Sea Link

Volume 9: Examination Submissions

Document 9.90: Applicant's Response to January Hearing Action Points from Compulsory Acquisition Hearing 1 (CAH1) and Issue Specific Hearing 2 (ISH2) – Deadline 4

Planning Inspectorate Reference: EN20026

Appendix D Figure D-1 (Rev A) NGET version of the Landscape Masterplan produced by SPR accommodating Sea Link and LionLink

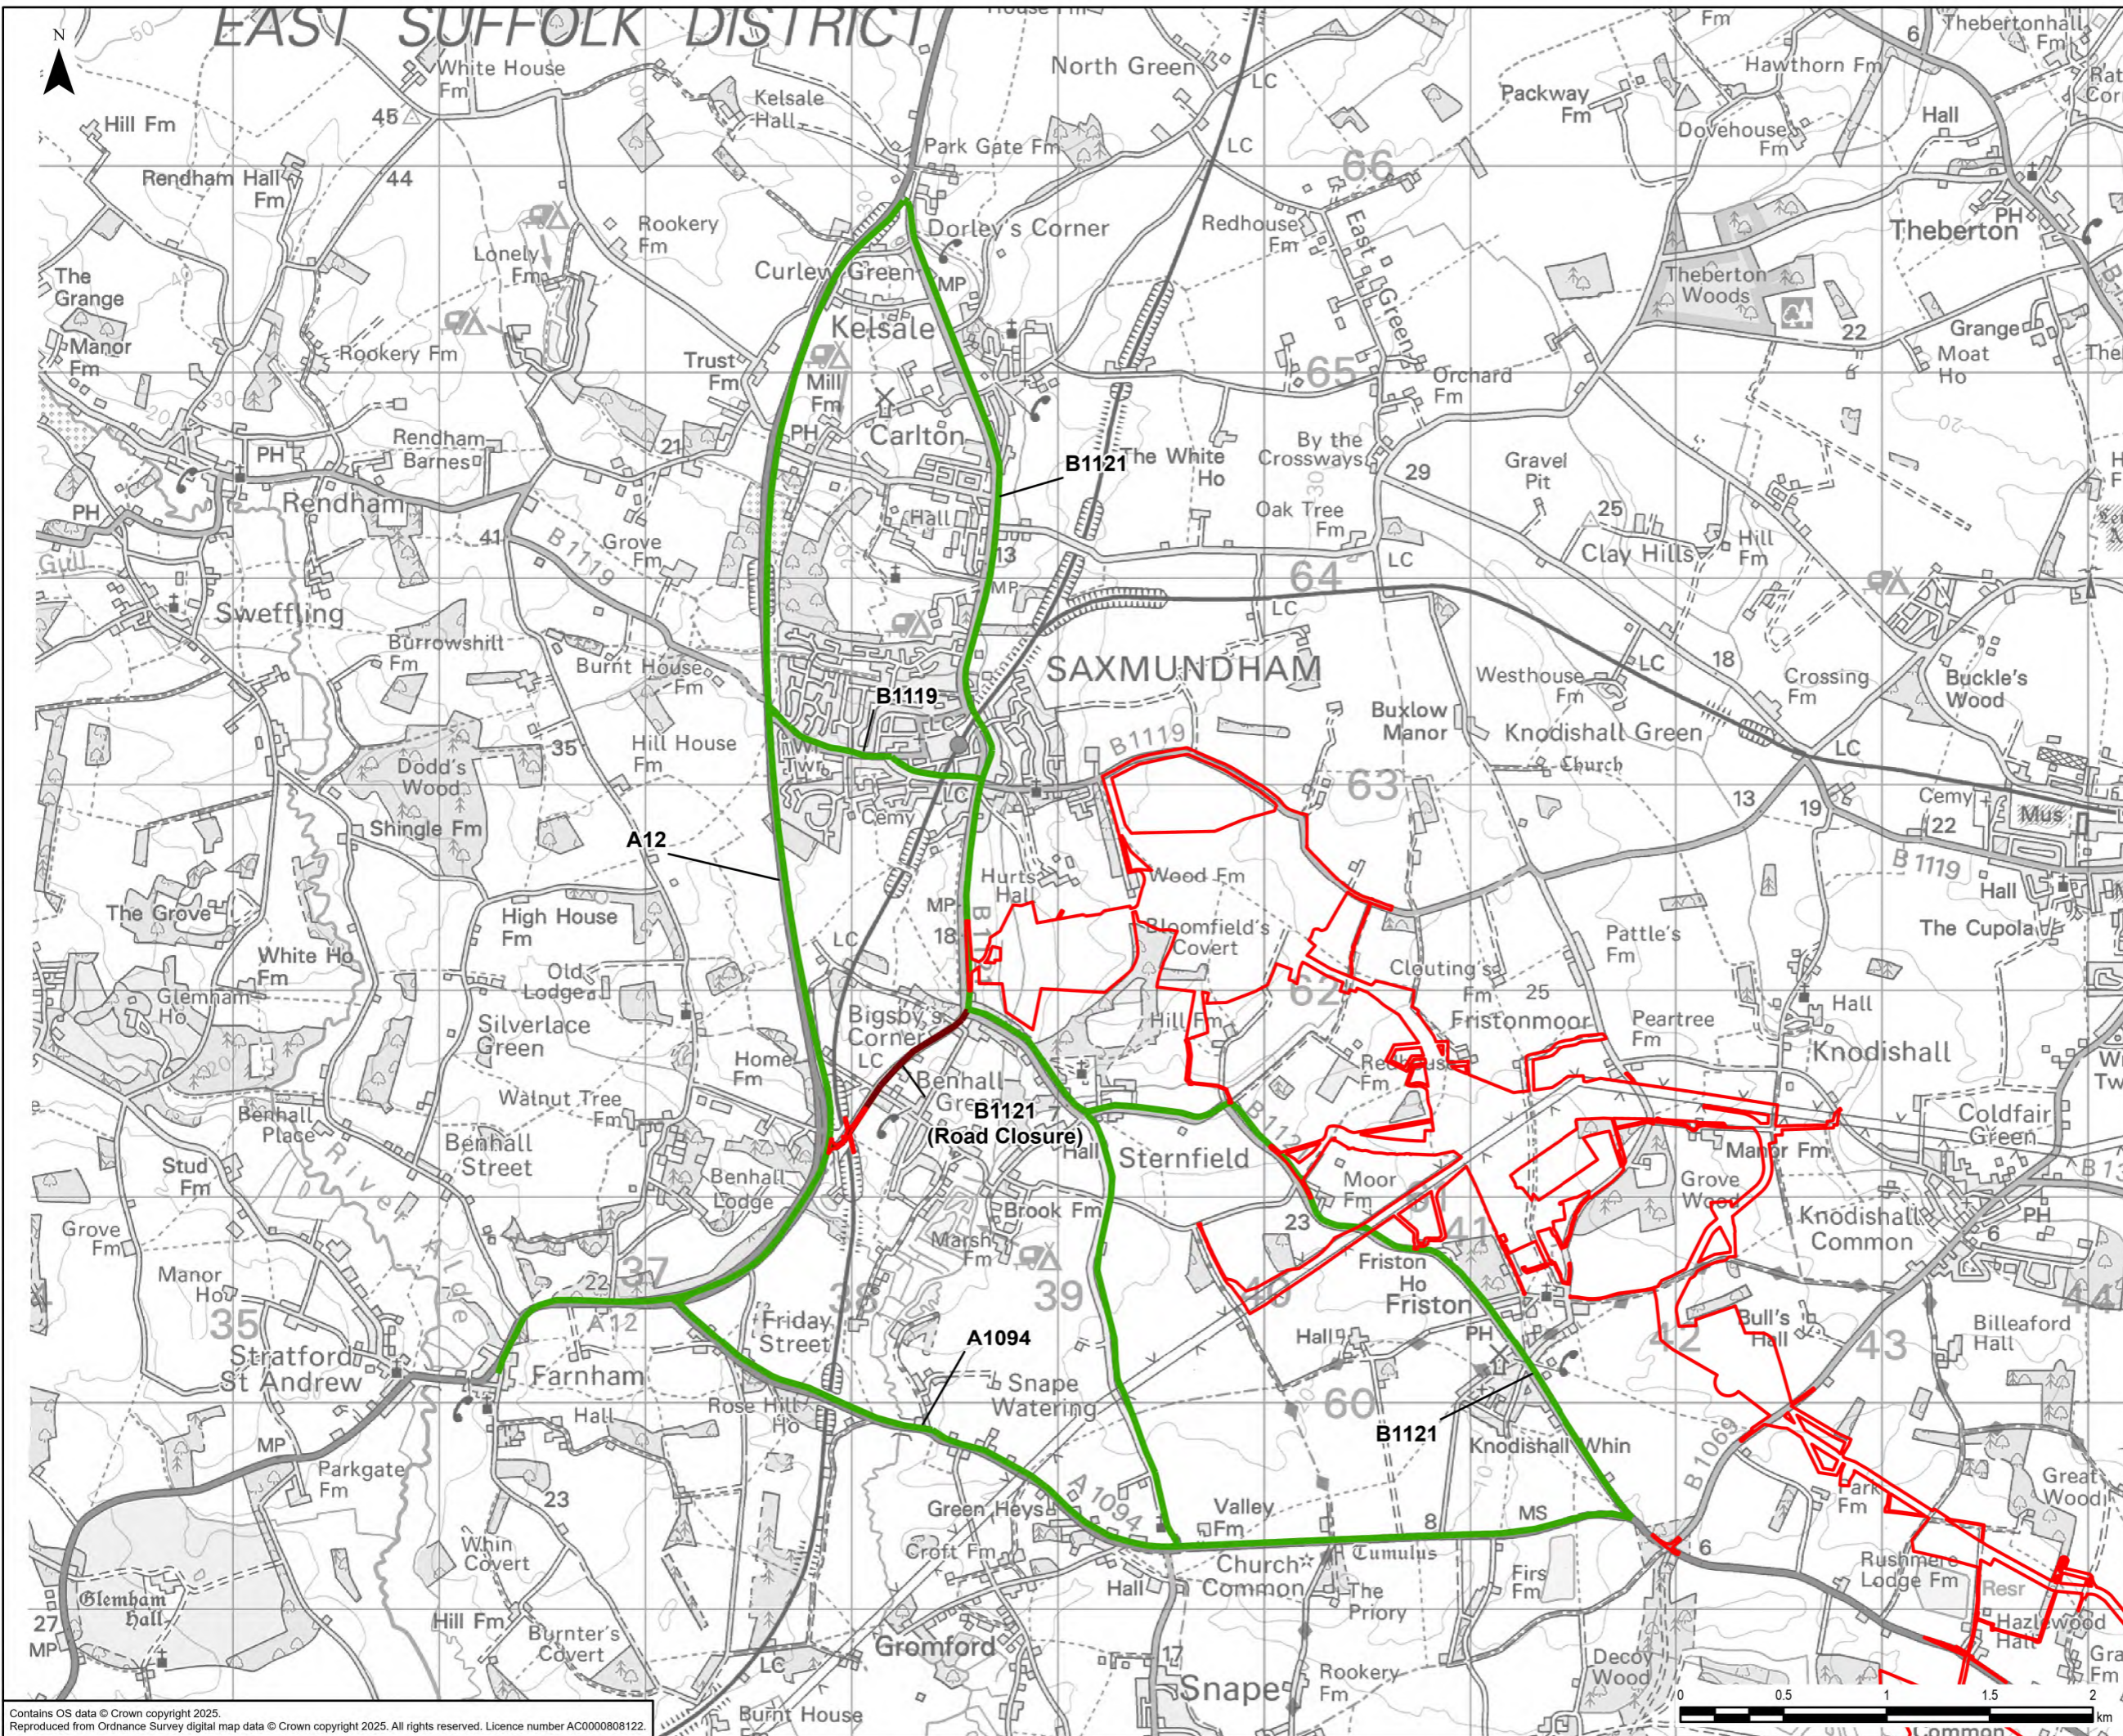
AP7	Clarify the need for the entirety of Suffolk plot 2/20 for mitigation given that no mitigation is shown in the outline landscape and environmental management plan (oLEMP) for areas of this plot.	Plot 2/20 is required to deliver environmental mitigation in the scenario (Friston Scenario 2) where Sea Link construct a substation at Friston, pursuant to the dDCO. Figure 5 in Application Document 7.5.7.1 (C) Outline Landscape and Ecological Management Plan – Suffolk submitted at Deadline 4 has been updated to reflect the landscape and ecological mitigation required. This updated plan reflects SPRs recently submitted substations landscape masterplan	Deadline 4

Action No.	ExA Description	Applicant's Response	Deadline
		(submitted to East Suffolk Council in December 2025) and allows for woodland planting, scrub planting, hedgerows and specimen trees and grassland across plot 2/20.	
AP8	Provide an explanation for a wider haul road/access road strip in Suffolk plots 2/20 and 2/7 when compared with Scottish Power Renewables (SPR) scheme. Consider whether the width can be reduced within the examination whilst still retaining veteran tree(s).	The areas where we require wider access than SPR for the access road are due to detailed design required on the diversion of a 33kv UKPN asset which is yet to be undergrounded, and in the area of a veteran tree which also coincides with the location of a drainage pond. This pond is indicative and may be removed later during the detailed design following further ground investigations	Deadline 4
AP9	Meet Mr Rix regarding impact on referenced plots including Christmas Tree plots and to provide further justification for need for planting adjacent to western access road and 18m screening. Provide an update on negotiations including response to Mr Rix request to be able to move agricultural machinery between fields within Suffolk plots 2/36 and 2/37 and review the need for the entirety of Suffolk plot 2/20 given Mr Rix's access requirements.	The Applicant has arranged a further meeting with Mr Rix and his agent to address his concerns and find a workable solution for both parties. The Land Rights Tracker and Schedule of Negotiations will be updated accordingly.	Deadline 4

Cumulative Scheme Construction Peaks compared to Sea Link (Suffolk)

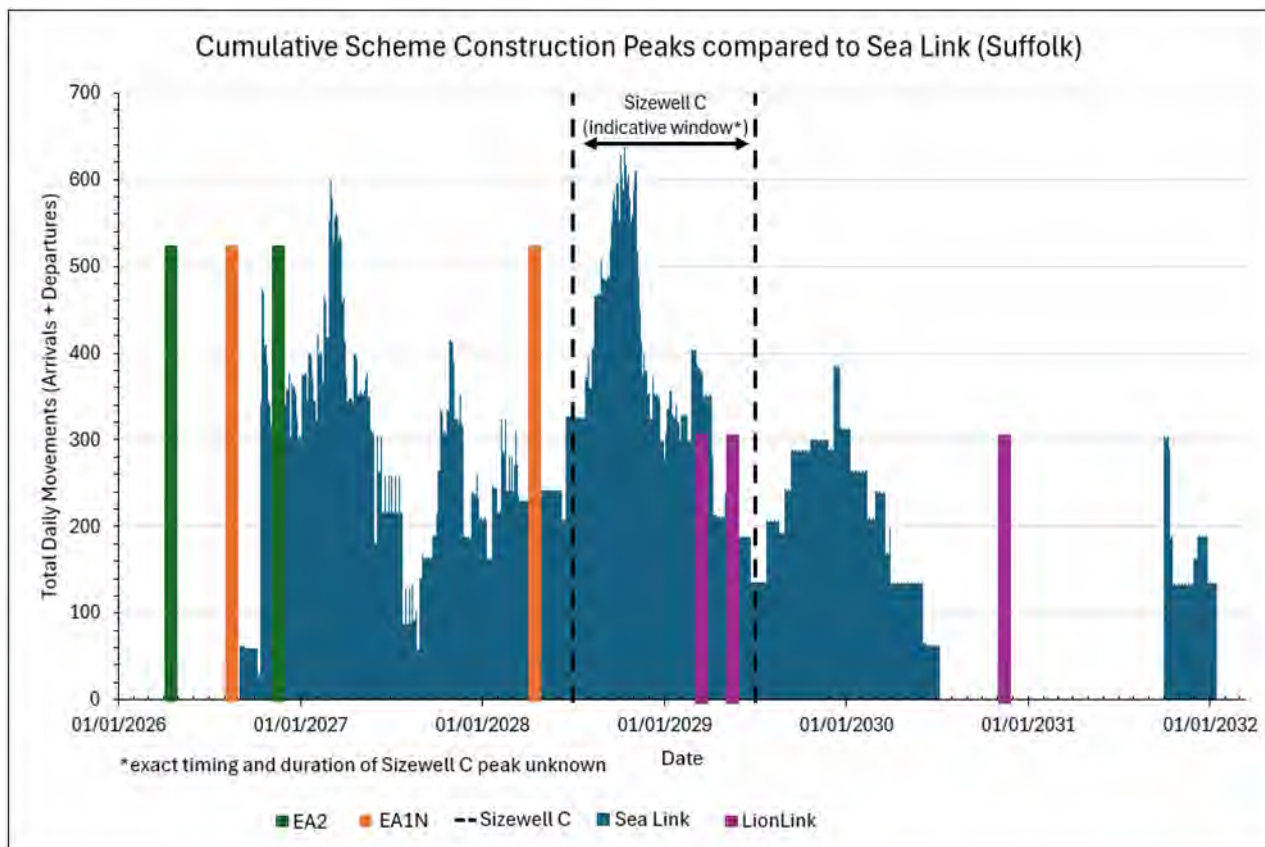
The below has been prepared following ISH2 to indicatively show the varying construction peaks of different cumulative schemes in Suffolk, based on the current understanding of when these are expected to occur. This indicates that the worst-case scenario of construction peaks of various cumulative schemes fully overlapping, is not a scenario that is expected to arise.
